8803070163 880225
PDR ADOCK 05000482
P DCD

DESIGN FEATURES

5.6 FUEL STORAGE

FIGURE 3.9-1

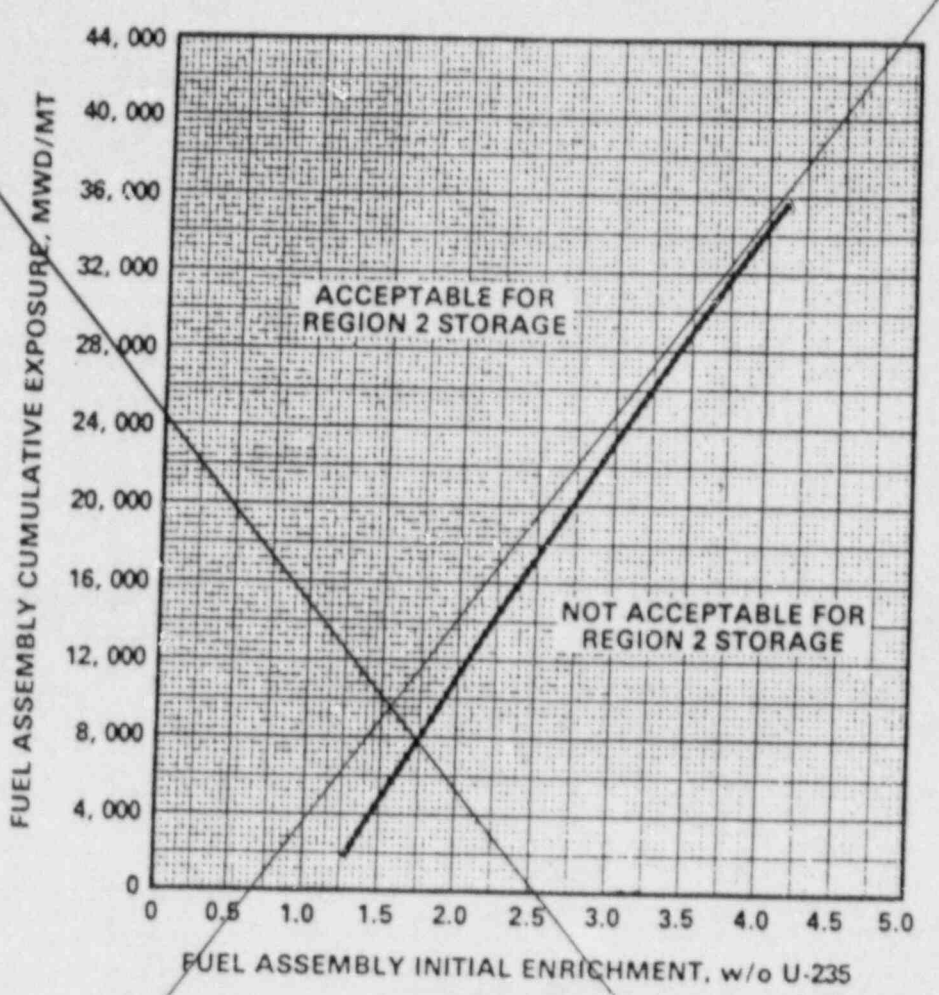
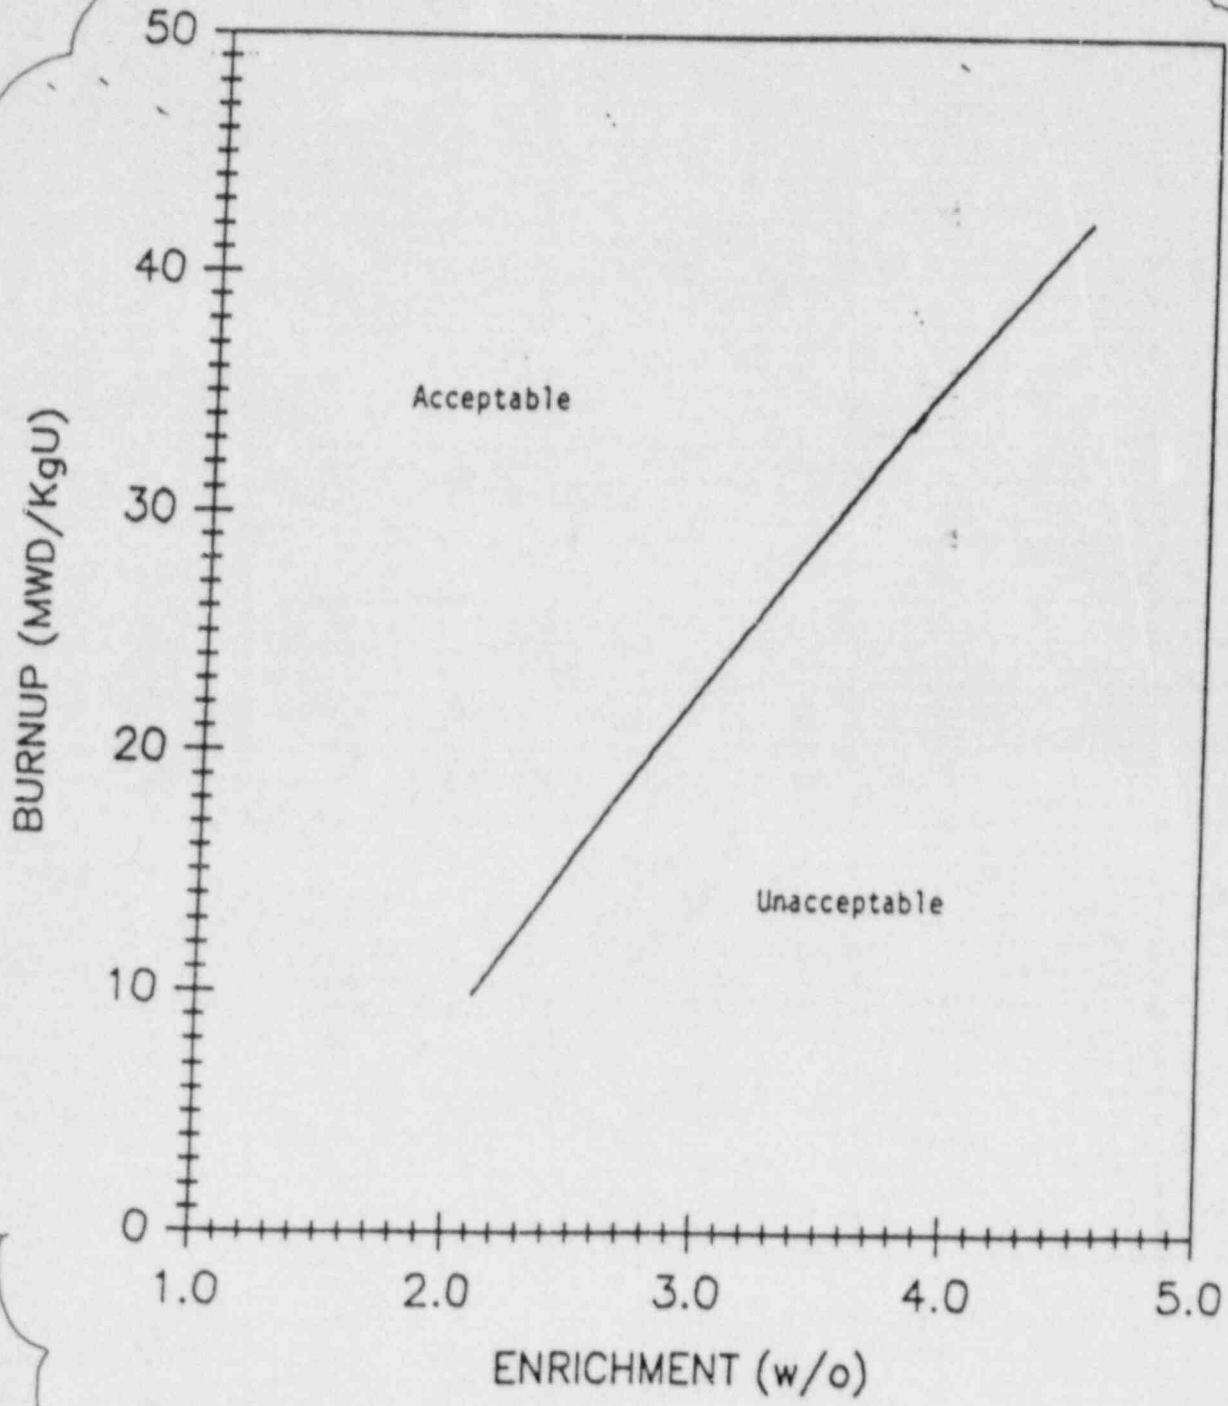
DELETE

INSERT

FIGURE 3.9-1 WOLF CREEK MINIMUM REQUIRED FUEL ASSEMBLY BURNUP AS A FUNCTION OF INITIAL ENRICHMENT FOR STORAGE IN REGION 2

FIGURE 5.6-1

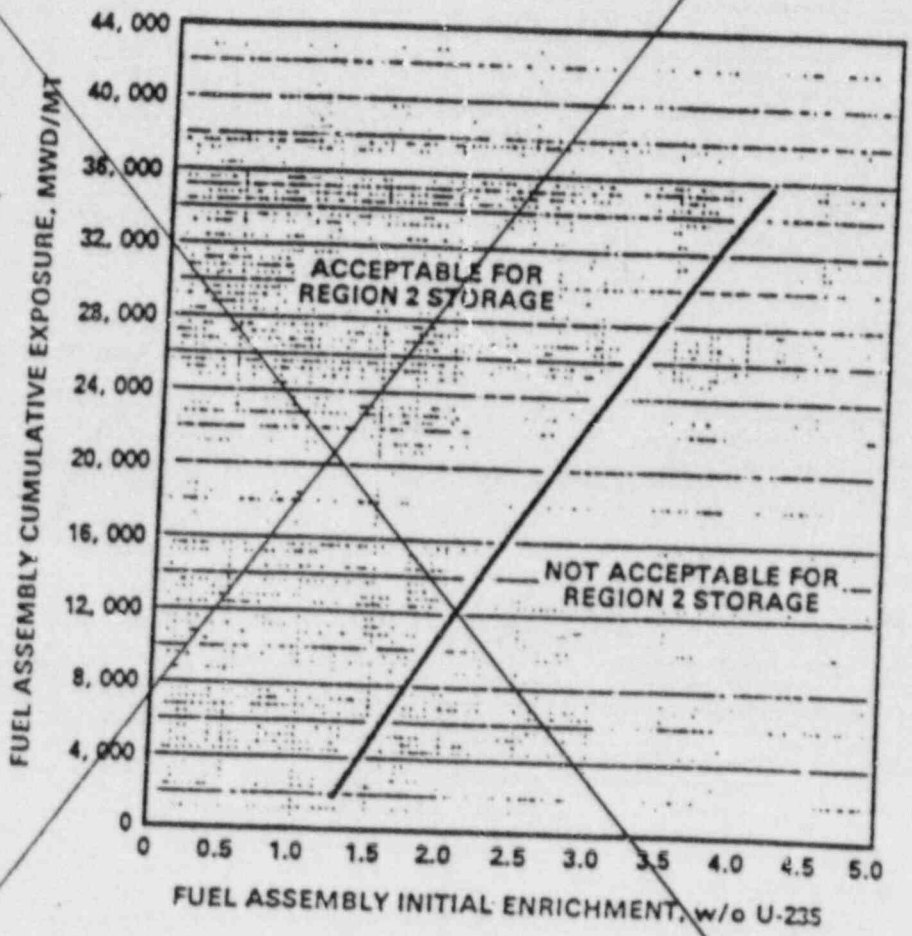
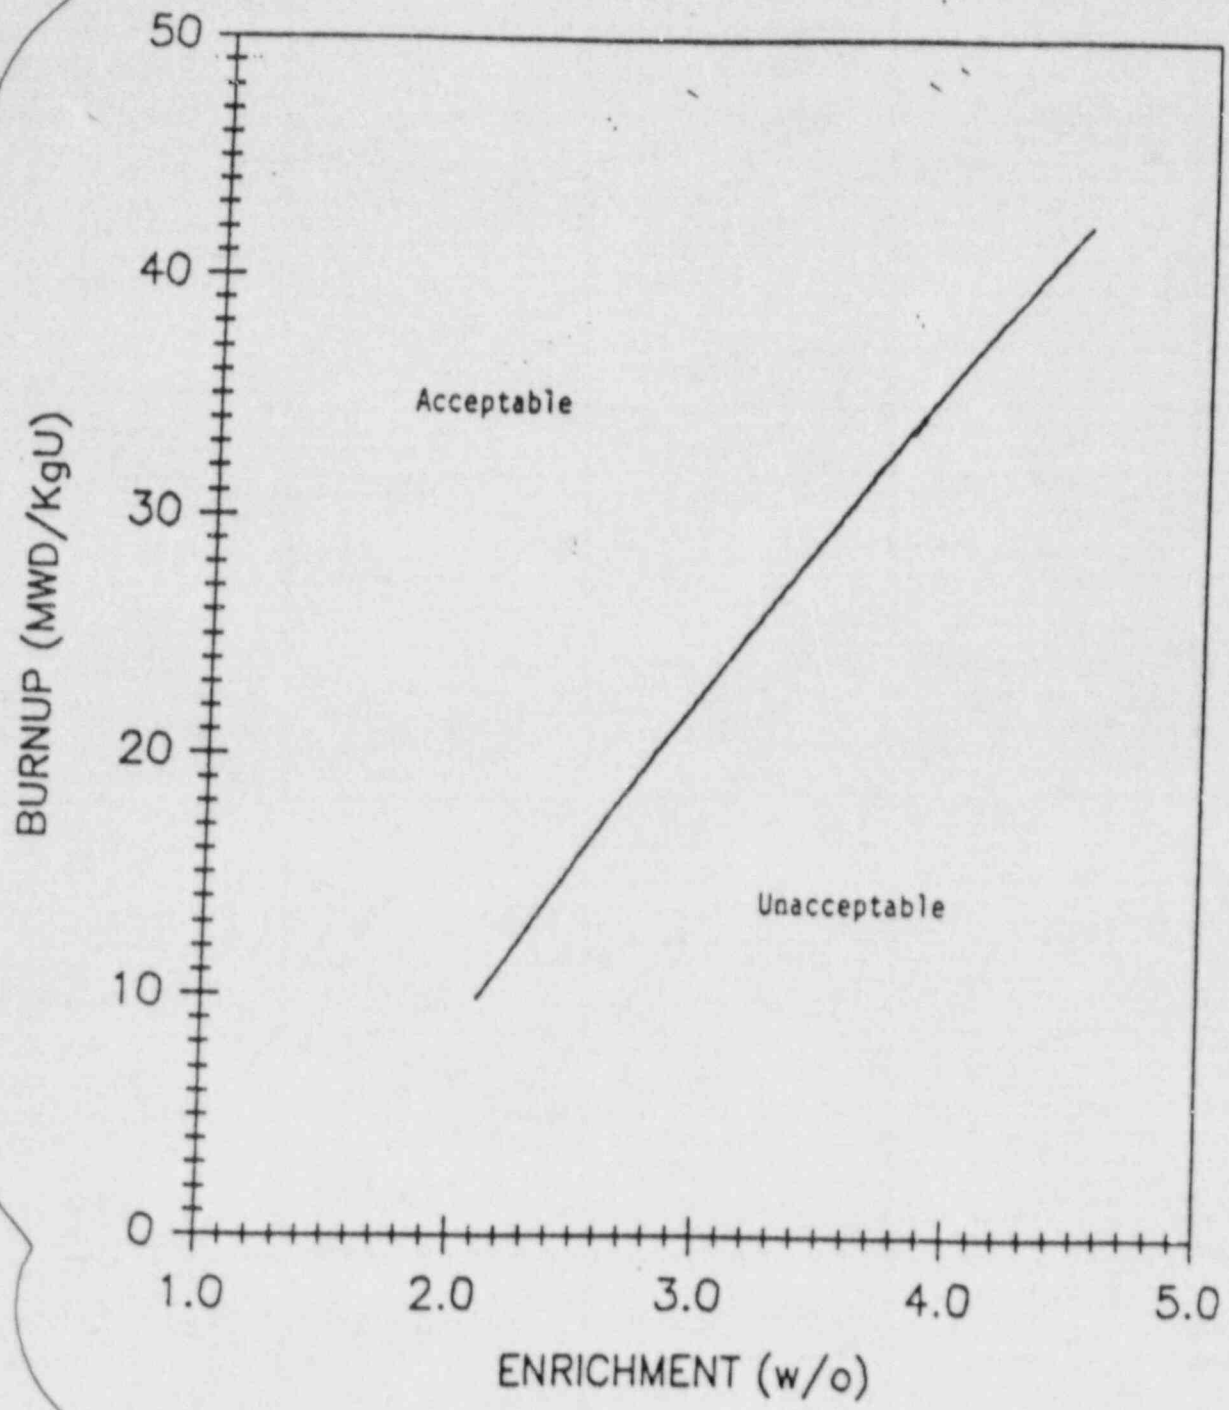
a. A k_{eff} equivalent to less than or equal to 0.95 when flooded with unborated water, which includes a conservative allowance of 2.6% $\Delta k/k$ for uncertainties as described in Section 4.3 of the FSAR. This is based on new fuel with an enrichment of ~~3.50~~ 4.50 weight percent U-235 in Region 1 and on spent fuel with combination of initial enrichment and discharge exposures, shown in Figure 5.6-1, in Region 2; and

DELETE

INSERT

FIGURE 5.6-1 WOLF CREEK MINIMUM REQUIRED FUEL ASSEMBLY BURNUP AS A FUNCTION OF INITIAL ENRICHMENT FOR STORAGE IN REGION 2
